**HISTORIC AND DESIGN REVIEW COMMISSION
COMPLIANCE AND TECHNICAL ADVISORY BOARD**

HDRC CASE NO: 2024-244
ADDRESS: 263 W HERMOSA DR
LEGAL DESCRIPTION: NCB 9016 BLK 8 LOT S137.61OF 56A,57A,S137.61 OF W20 OF55A S137.61 OF E 15 OF 58A
ZONING: R-4, H
CITY COUNCIL DIST.: 1
DISTRICT: Olmos Park Terrace Historic District
APPLICANT: Joey Cortez/CHAPA FEDRA
OWNER: Joey Cortez/CHAPA FEDRA
TYPE OF WORK: Roof replacement (shingle to metal)
APPLICATION RECEIVED: June 24, 2024
60-DAY REVIEW: August 23, 2024
CASE MANAGER: Claudia Espinosa

The applicant is requesting a Certificate of Appropriateness for approval to replace the existing shingle roof with a standing seam metal roof in the color aged bronze.

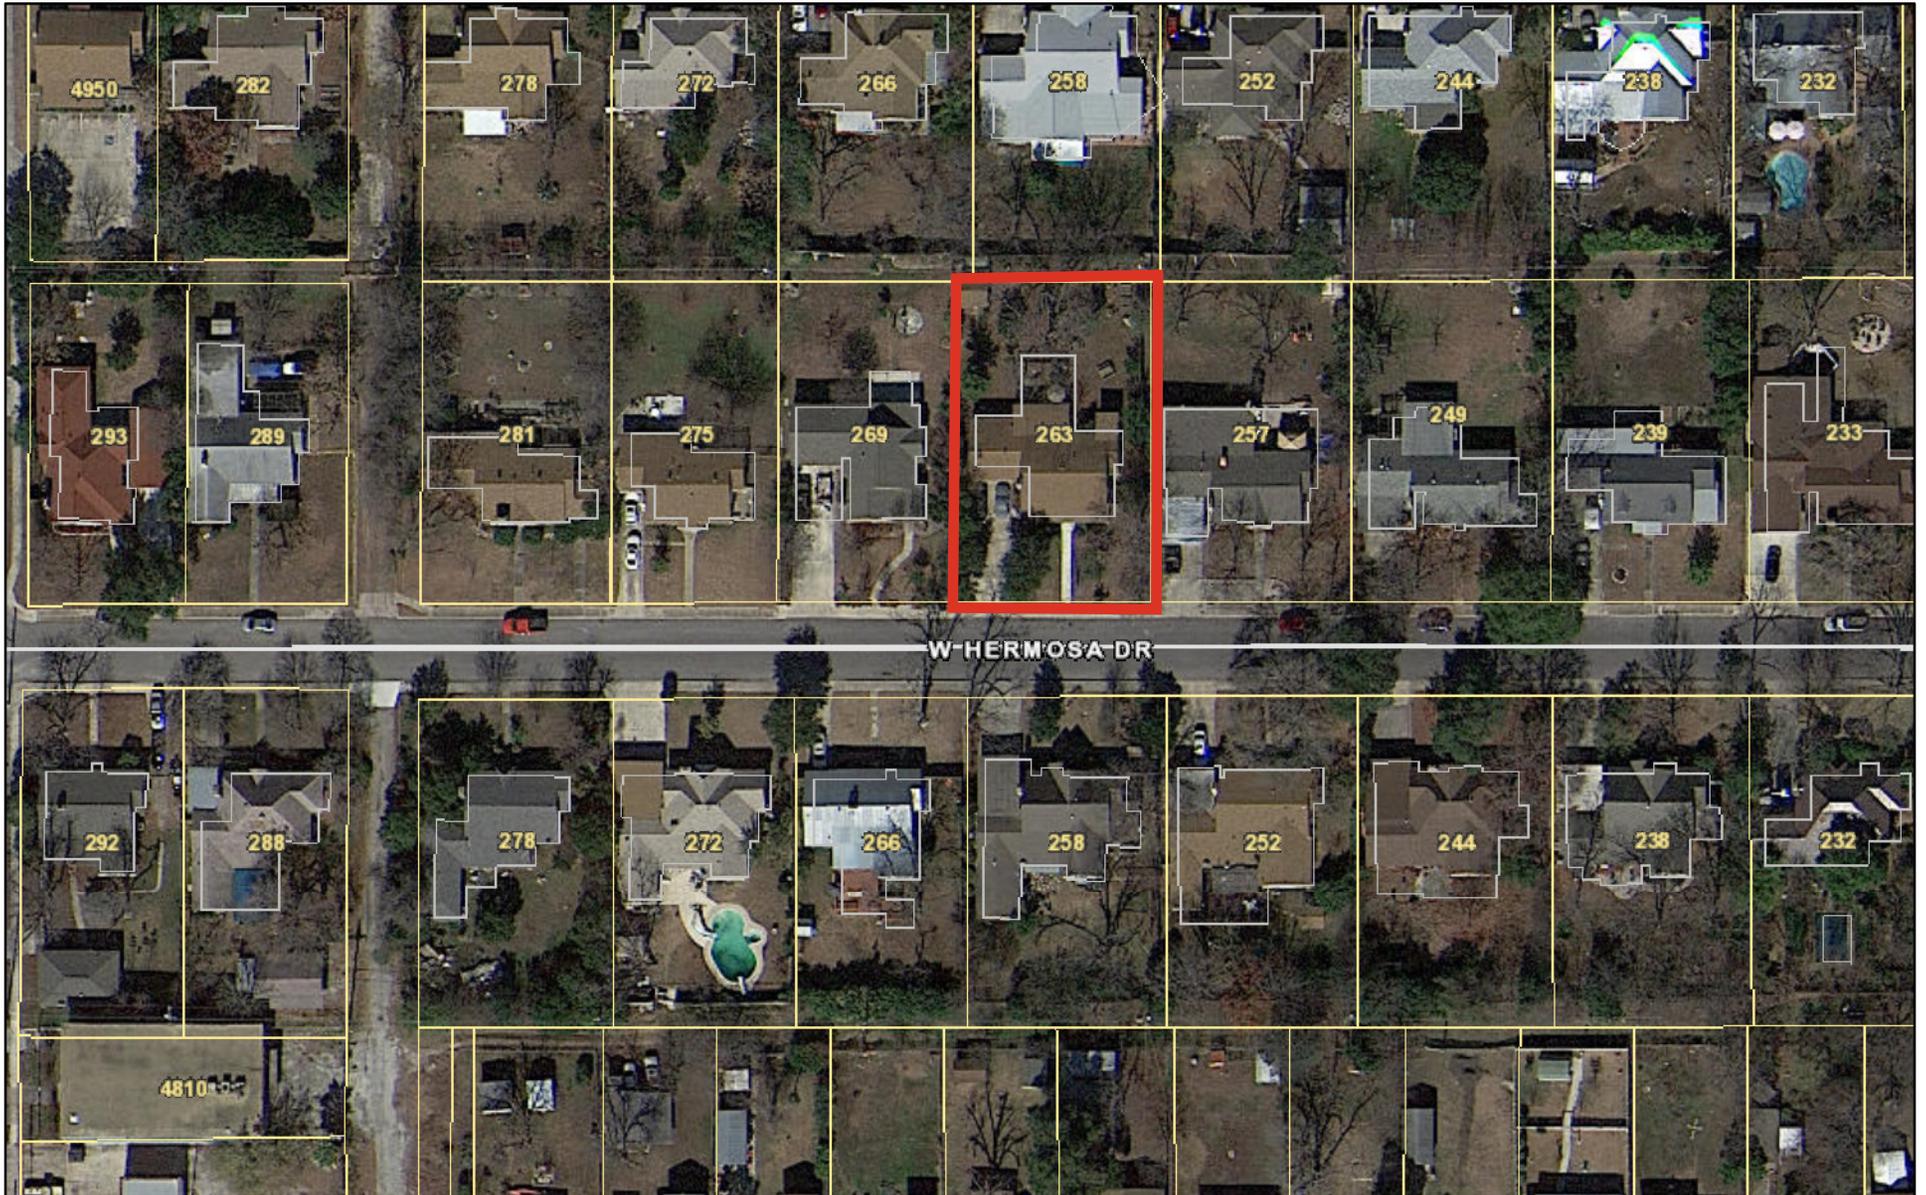
- a. The structure located at 263 W Hermosa is contributing to the Olmos Park Terrace Historic District and was constructed circa 1955. The structure does not appear on Sanborn Maps but makes its first appearance in the 1955

Historic Aerials and City Directory. The structure is a single-family stone structure has a full-length front porch with a front door flanked by a set of ganged windows on the front facade, stone chimney, and a shingle roof.
